Project Name: Golden Court Subdivision

Preliminary Review Agencies Comments

Subdivision Golden Court Final Plat

Re: FILE #71-77 - PRELIMINARY PLAT - GOLDEN COURT SUBDIVISION

INDEX MAP

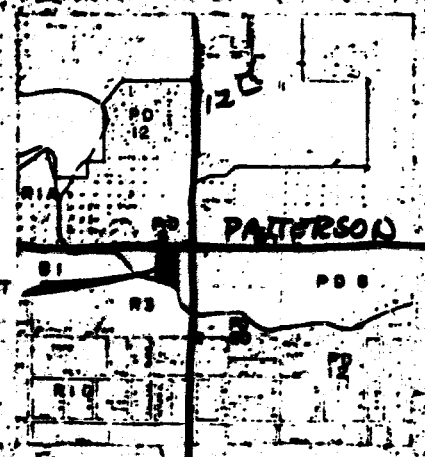
Mountain Bell - easements inadequate will require 15' in width as shown on plat
Public Service electric - OK 75' over 20' off property at Glen Dale N. - east side
Western Slope Gas - the easement covers WSG gas regulator metering station. see info.
City Utilities - 6" dead end water line NOT ADEQUATE for fire protection - 8" MIN.
City Engineer - a) foundations should be engineered b) power of attorney for all improvements on Patterson Rd. (No C.G., S.W. on Glen Dale N. of New R.O.W. W.)

c) EXISTING WASTE DITCH ON S. ^{needs improvement to handle ADD'L drainage} IS NOT ADEQUATE. Dev. should IMPROVE WASTE DITCH TO THE ~~large~~ large DRAIN TO THE WEST. City Eng. will require location AND specs. for ditch with the utilities composite at final plat stage. Easement to the city will be req'd for the ditch

① Check if easement for drainage ditch can be obtained. Need Power of attorney for full 1/2 street improvements for Patterson Road.

② 2" water line is not acceptable. Require min. 6" to end of cul de sac.

- (1) Fire hydrants and waterline sizes as required by City Fire Department. (minimum eight inch dead end line)
- (2) Engineered foundations will be required on all structures built in this subdivision. A statement to this effect must be on the final plat.
- (3) Power of attorney for half street improvements on Patterson Road.
- (4) Rename Glen Dale to 11th Court.
- (5) Use and necessary improvement of existing waste ditch must be coordinated with the city engineer prior to final plat submission. This ditch should also be included in the utilities composite required to be submitted with the final plat.
- (6) All engineering firms in Grand Junction were sent updates of final plat requirements dated

- 1) Power of attorney for full half street improvements for Patterson Road.
- 2) Minimum six inch water line instead of two inch as shown.
